**NATIONAL IMAGERY TRANSMISSION FORMAT STANDARD (NITFS)
REQUEST FOR CHANGE (RFC)**

RFC CONTROL NUMBER 97-002

DOCUMENT NITFS CERTIFICATION TEST &
EVALUATION PROGRAM PLAN

PARAGRAPH 5-24.L

Figure 5-Y. Control Lead Timing Sample from a Half Duplex Transmission.

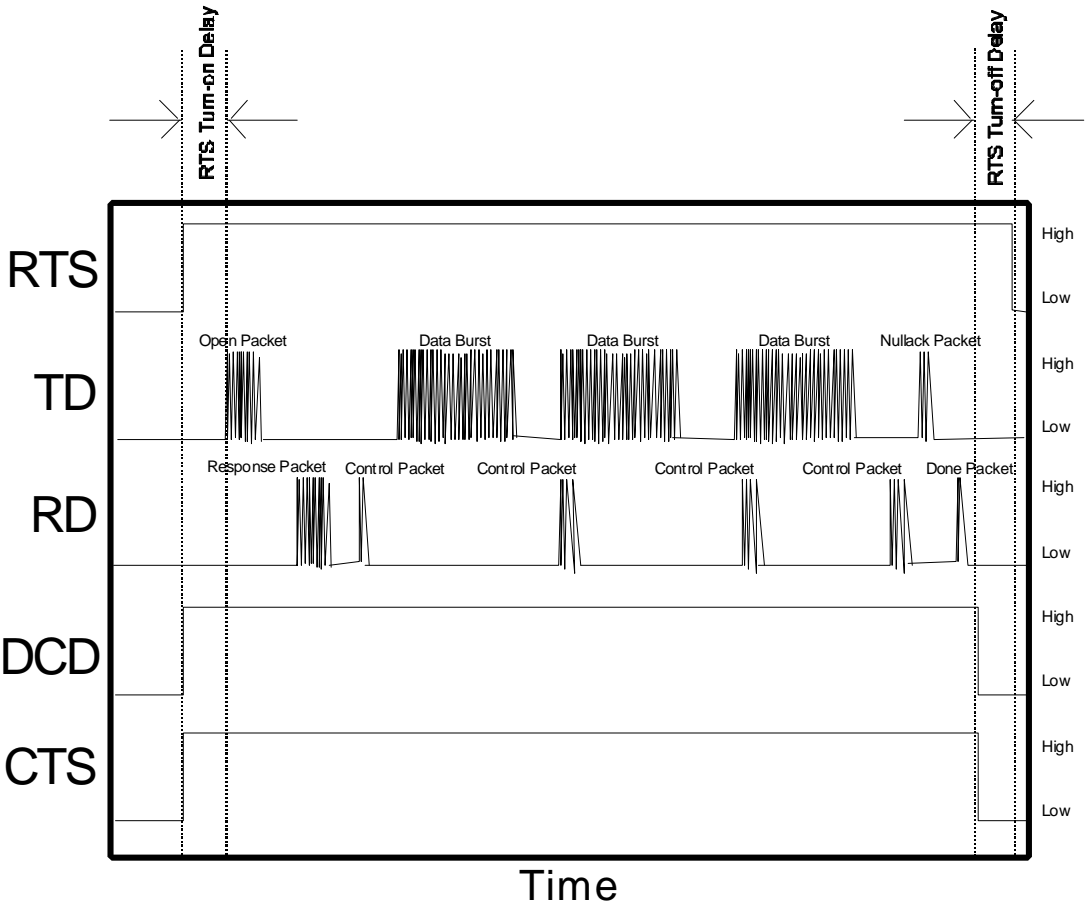
The Check for DCD should occur before the half-duplex turn-around delay.
The Check for CTS should occur immediately after raising RTS.

b. Half Duplex. In half duplex mode, RTS must be kept low between buffers to allow for incoming packets to be received. In half duplex mode, the implementation must wait a user-specified amount of time (half duplex turn-around delay) after checking for DCD to be dropped low (if the DCD check is enabled) and before raising RTS.

b. Half Duplex. When enabled, in half duplex mode, the implementation must check and wait for DCD to be low before waiting the half duplex turn-around delay and before raising RTS.

Figure 5-X. Control Lead Timing Sample of an entire Full Duplex Transmission.

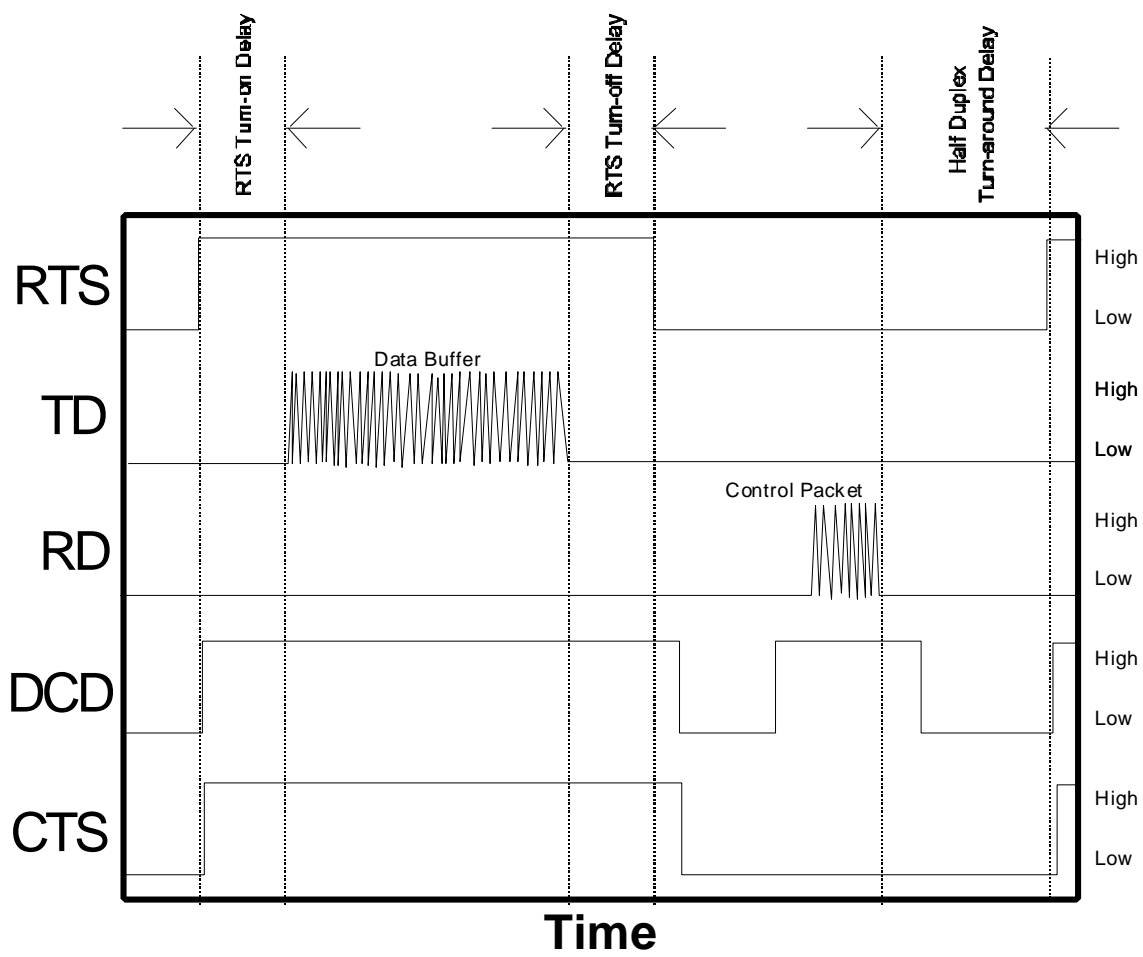
System is set to keep RTS high throughout the transfer.
The Check for DCD should occur immediately after raising RTS.
The Check for CTS should occur immediately after the Check for DCD.

a. Full Duplex. In full duplex mode, RTS may either be kept high throughout the transfer or lowered between transmission bursts.

a. Full Duplex. When enabled, in full duplex mode, the implementation must check and wait for DCD to be high. In full duplex mode, the check for DCD should occur after raising RTS and before checking for CTS to be high (if the CTS check is enabled) and before initiating the RTS turn-on delay.
